Submission of Annual Geotechnical Inspection – 2024, Mary River Project – Nunavut, Project # CA0039374.4332

2024 Geotechnical Inspection Recommendations and Implementation Plan

Figure 2: Mary River Site layout – North-Eastern Zone – Waste rock stockpile facility (MS-08) and geotube ponds.

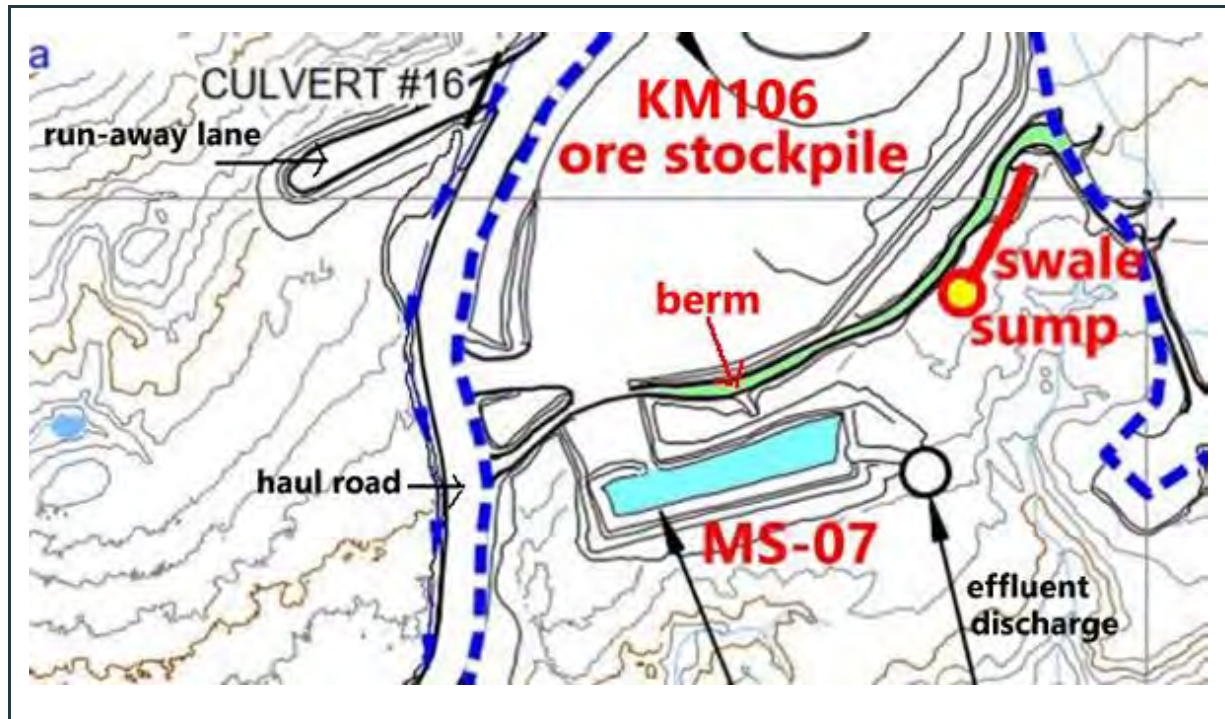
During the August 2024 inspection, the MS-08 pond was almost empty, as shown in Figure 28. Figures 29 and 30 show the well-maintained drainage ditches (east and west) around the waste rock storage facility, conveying the collected surface water to the MS-08 pond.

Figure 32: Section at the upstream side of the main dam (note the detail within the red rectangle at the left, showing an anchor trench into the permafrost). – Source: KM105 Sedimentation Pond Design Brief and Issued for Construction Drawings – Knight Piésold Ltd. 2021

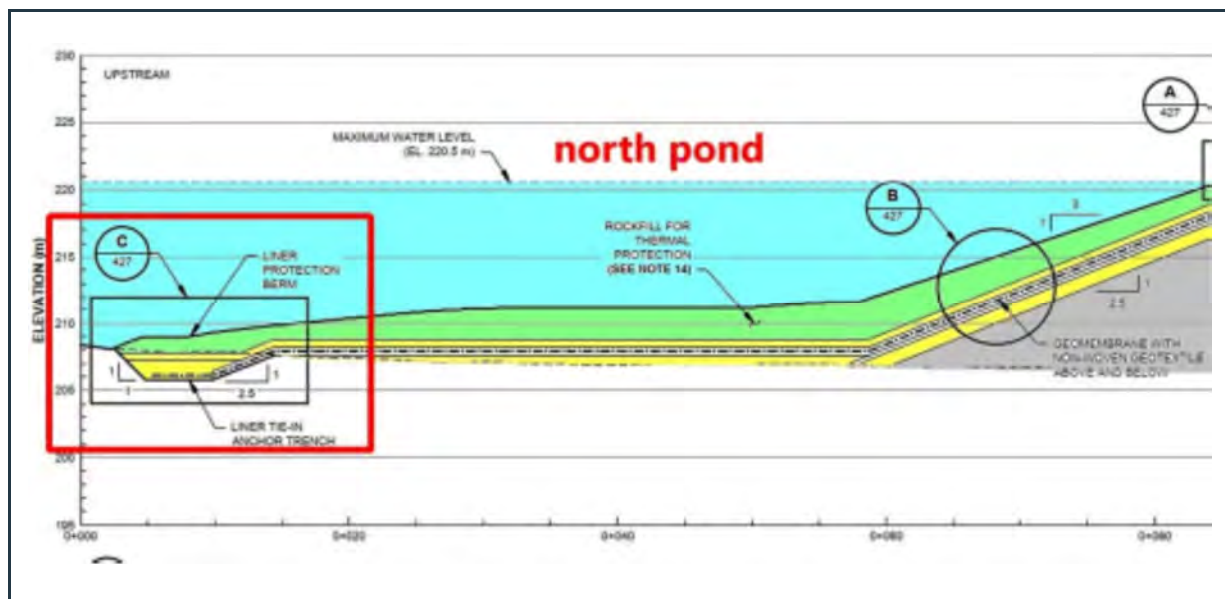
The design of the pond's main dam included an emergency spillway with an invert elevation of 220.5 m, which is the design maximum water level in the MS-11 pond. At normal water level the pond has two separate (but connected) areas: the "north and south ponds", as shown in Figure 4. As specified in the 2021 design, the upstream slopes of the main dam and sections of the side slopes within the north and south ponds (yellow areas in Figure 4) are lined with HDPE geomembrane, placed between two layers of non-woven geotextile, and gravelly sand base and cover layers, and topped with a layer of crushed rock riprap for erosion protection (see Figures 32 and 33).

Figure 34: Section of the side slope in the south pond. – Source: KM105 Sedimentation Pond Design Brief and Issued for Construction Drawings – Knight Piésold Ltd. 2021

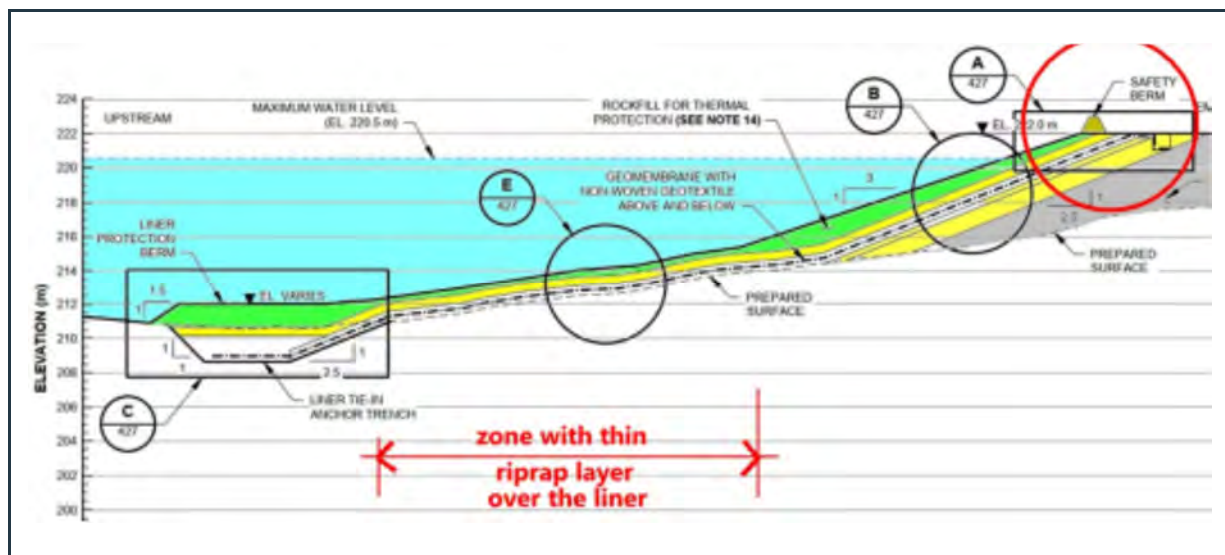
On the side slope of the south pond, the geomembrane liner and non-woven geotextiles extended up to the top of the slope of the embankment and were anchored into an anchor trench at the crest, as shown in Figure 34.

Two things could be noted in the Figure 34 image:

- The other is that one of the safety berms, constructed on the top of the riprap layer, immediately adjacent to the anchor trench at the crest of the embankment (see the red circle in the image). Based on information recently obtained at the mine it appears that during the filling of the ponds with runoff water, around June 11 and 12, 2022, sliding/sloughing of the cover layers and the displacement of the safety berm was noted along the crest of the embankment at the south pond. Figure 35, which was taken on June 22, 2022, shows the slipping (and cracking) of the cover layers (sand and riprap) and the downslope displacement (sliding) of the safety berm just a few weeks after the completion of the construction and during the early stage of filling the pond with water.

Figure 40: View of the well-maintained stable berm and interior granular fill over the liner at the new fuel tank farm. Note the ponding water in the cell, indicating good liner performance.

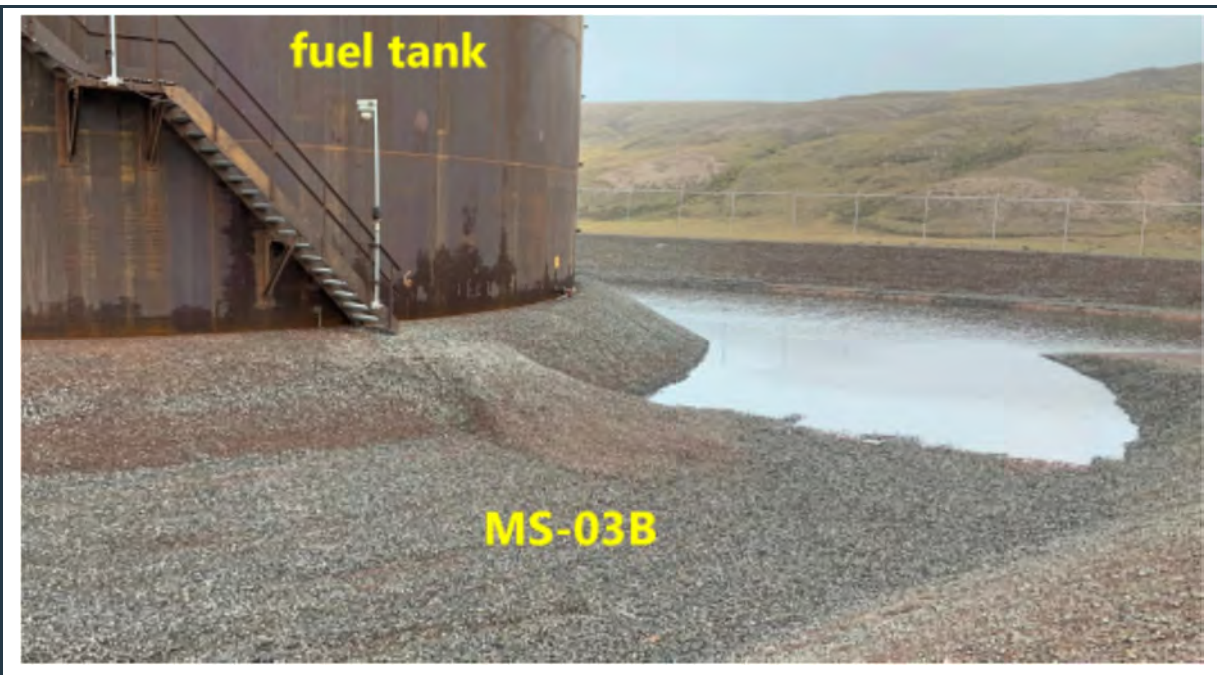
A large capacity fuel tank farm is located adjacent to the Tote Road, as shown in Figure 40. This tank farm was constructed as specified in the design drawings (subgrade, berms, bedding layer, liner, and protective cover). Based on site observations during the August 2024 visit (presence of ponding water in the cell), the liner in the facility is intact, and the perimeter berm is stable and well maintained.

Figure 41: Satellite view of the solid waste landfill facility and the adjacent two, recently constructed landfarm cells (1 and 2). Cell 3 is proposed for construction in the future.

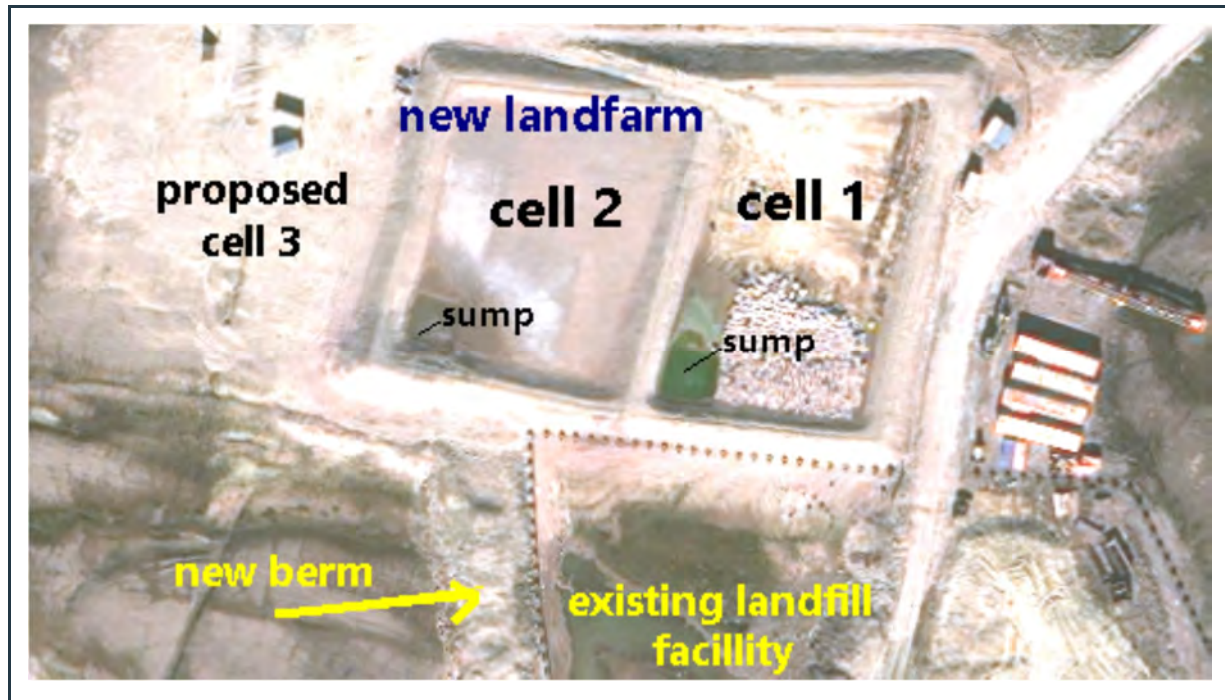
The non-hazardous solid waste disposal area is in the southern zone of the Mary River Mine site, as shown in Figure 6. Two (2) new landfarm cells were constructed near the gate of the main landfill facility, as shown in Figure 41. It is understood that the number of new landfarm cells may be increased to three (3) as shown in the image.

Figure 44: View of the stable berm around the currently empty cell-2 of the new landfarm. The ponding water indicates good liner performance. Note that the water should be removed prior to storing any material in this cell.

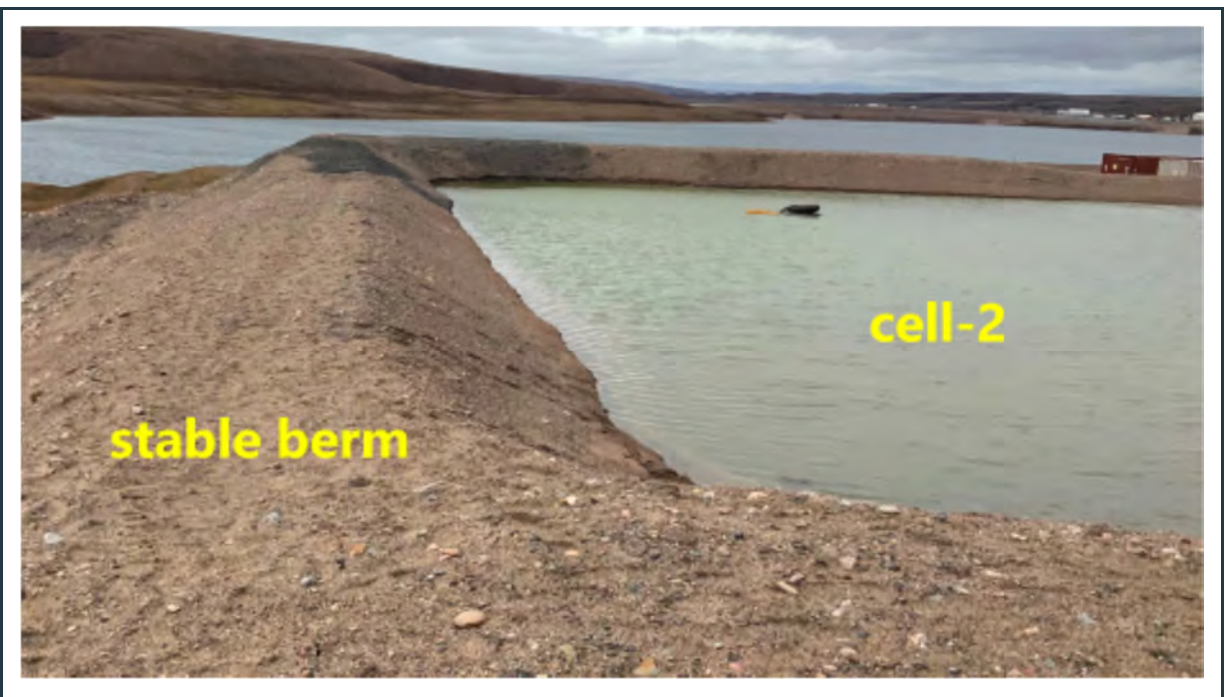
Figures 43 and 44 show the robust stable berms around the cells. During the August 2024 inspection it was noted that the currently empty cell #2 had lots of ponding water within the cell. This indicates good liner performance; however, the water should be removed and properly disposed, prior to storing any material within the cell.

Figure 45: View of the upgraded Camp Lake check dams and new gabion wall in good conditions, constructed along the road to the lake.

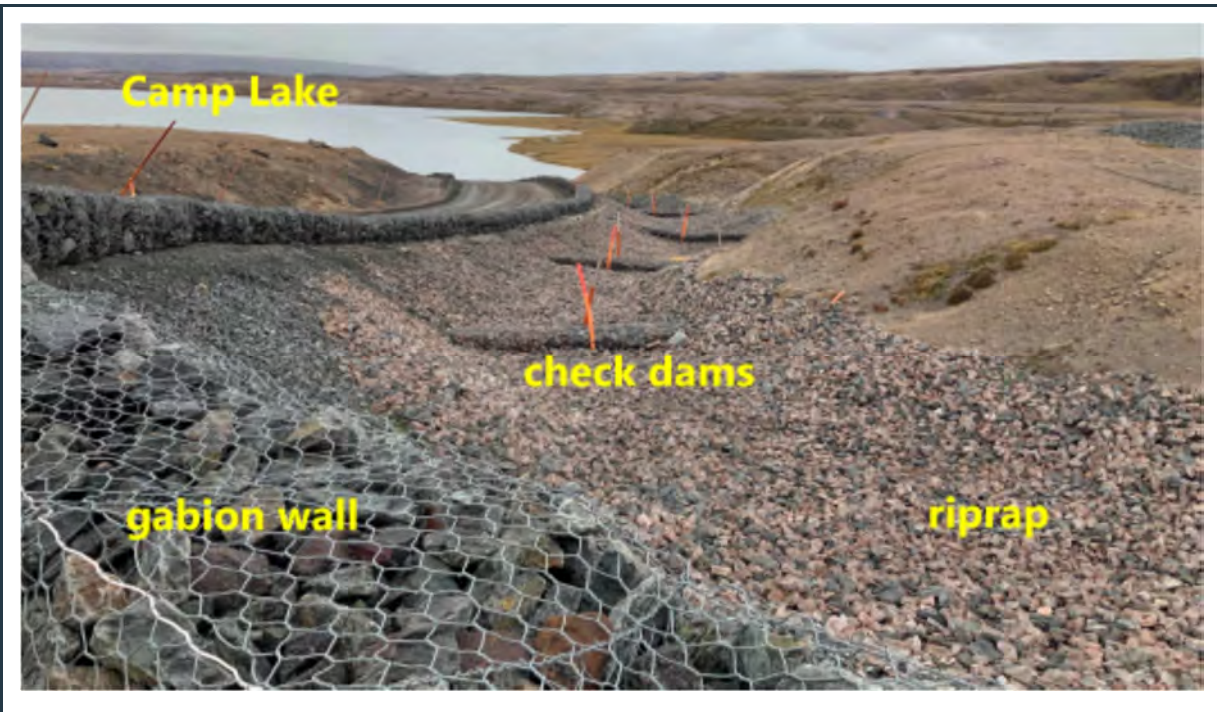
The Camp Lake check dams and gabion walls (all stable and well-maintained) are located along the access road to the mine's water intake jetty. The primary purpose of these structures is to collect (trap) fine soil particles (silts and clays) that could be eroded down from the adjacent slopes, and to prevent the siltation of the lake around the water intake structure. As shown in Figures 45 and 46 the rockfill riprap in the channel and the check-dams have been recently upgraded and a new gabion wall was installed along the road to the lake. The images show that the check-dams are working well, as intended. Figure 46 also shows a new check-dam and gabion wall, constructed adjacent to the lake to capture suspended solids (silts and clays) potentially eroding from the nearby airfield area and to prevent siltation in the lake.

Figure 52: View of the new drainage ditch/swale and sump pit south of the KM-106 ore stockpile area, collecting local run-off. Note the recently completed riprap erosion protection along the sides of the swale and sump. Water from the sump is pumped into the nearby MS-07 pond.

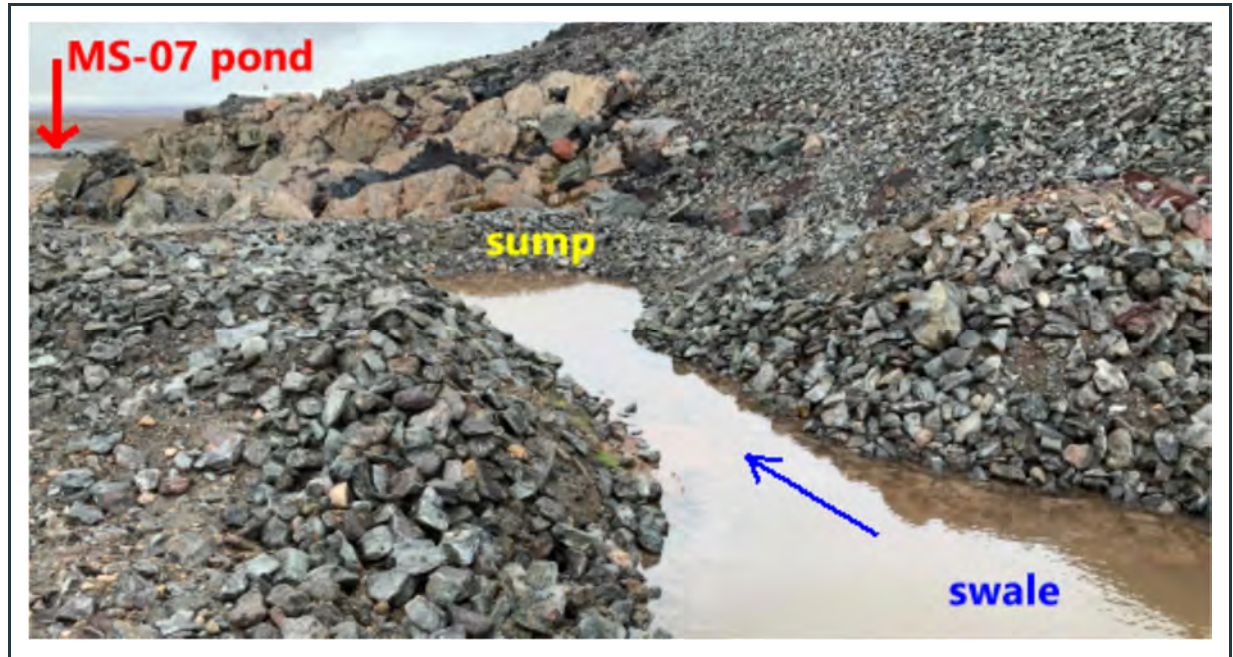
Figure 50 shows a historic image (2022) of the diversion berm, drainage ditch/swale and sump in poor conditions. However, as shown in Figures 51 and 52, these infrastructure components have been recently rehabilitated/upgraded. The diversion berm was reshaped and raised somewhat, while the slopes and base of the drainage ditch and sump are now covered with riprap to minimize siltation of the collected water, which is being pumped into the nearby MS-07 pond.

Figure 58: View of the well-maintained stable perimeter berm around the lined MP-03 fuel tank farm. The ponding water indicates good liner performance.

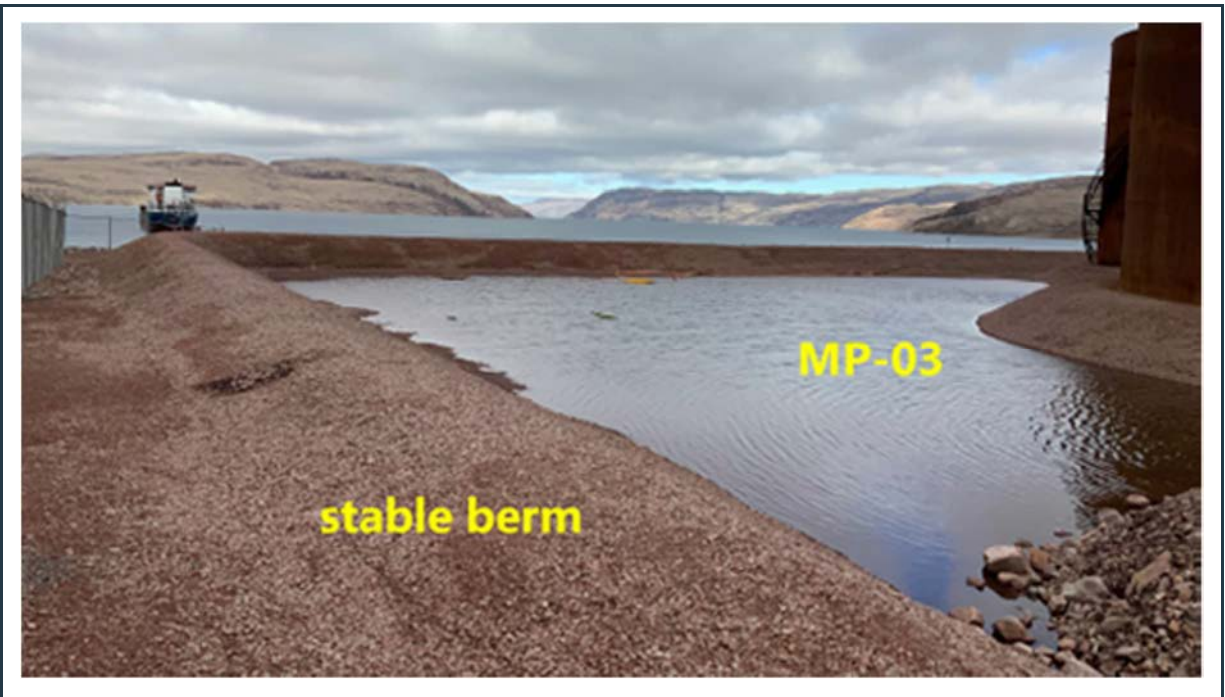
The MP-03 fuel tank farm occupies a large area in the center of the Milne Inlet Port. As shown in Figure 58, the facility is well maintained and the perimeter berm around the site is in excellent condition. The presence of ponding water in the facility is an indication of good liner performance. The site is fenced in, and no indication of instability or seepage was noted at and around the robust berm at this facility.

Figure 62: View of the robust, stable perimeter berm and intact liner at the MP-05 pond.

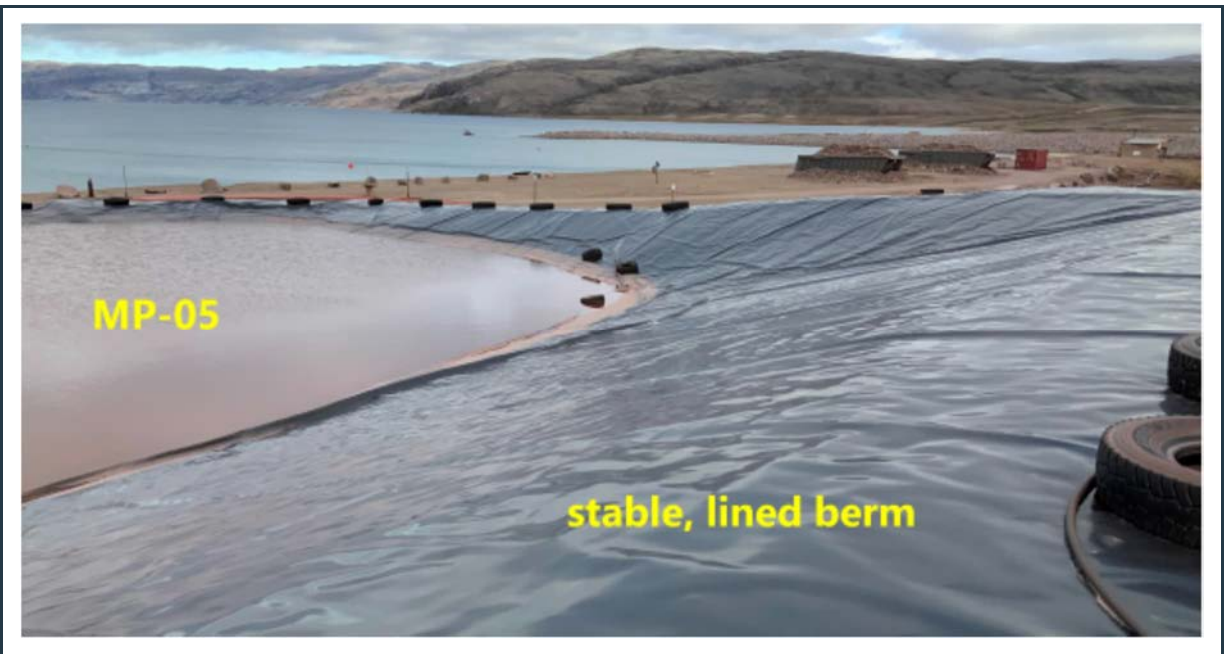
No instability, erosion or settlement was noted at the robust berms of the MP-05 pond and no toe seepage from the pond is visible anywhere around the pond's perimeter berm, as shown in Figure 62. The surface water from the ore stockpile is collected in well-maintained, clean drainage ditches, including the well-maintained east ditch, shown in Figure 63.

Figure 64: View of the lined MP-06 pond with robust, stable berms. Note the lined intake channel at the far-left end of the pond.

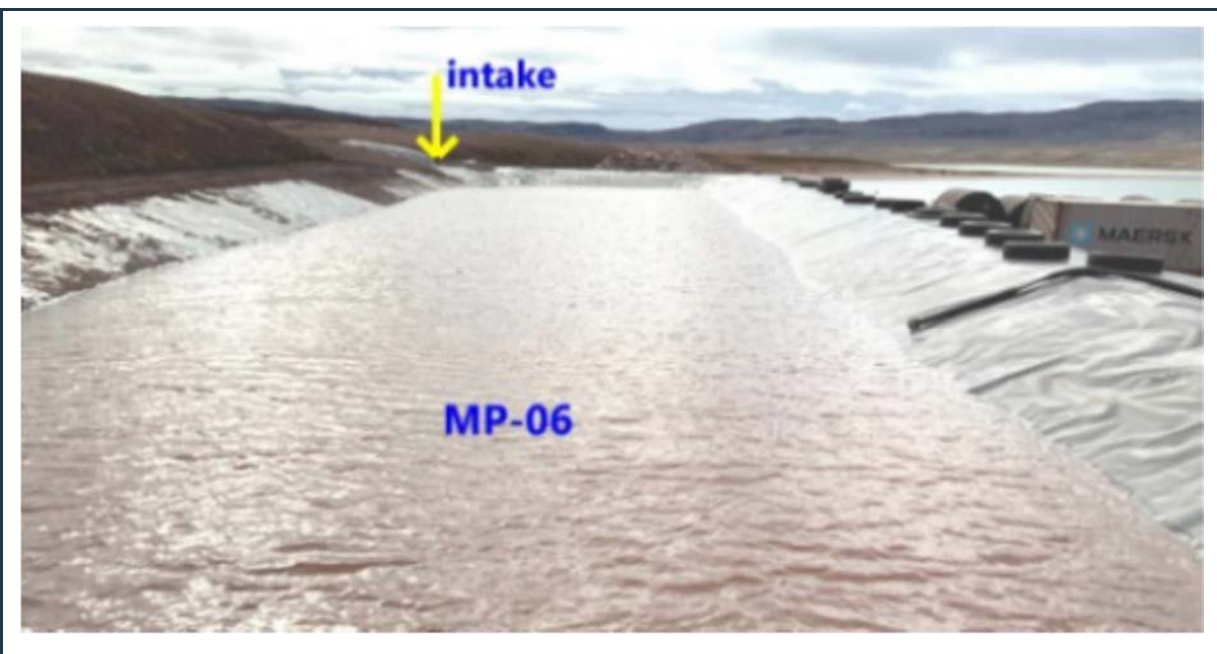
The large "twin" surface water management pond adjacent to the north-west corner of the ore stockpile area is divided into two (2) cells (MP-06 and MP-06/A) by a liner-covered internal berm. The main (south) part of the pond is called MP-06 and is shown in Figure 64. The northern cell is called the "overflow pond" MP-06/A, shown in Figure 65. The liner in the ponds and the stable, robust perimeter berm are in good condition, and no seepage was noted from the ponds, indicating good liner performance.
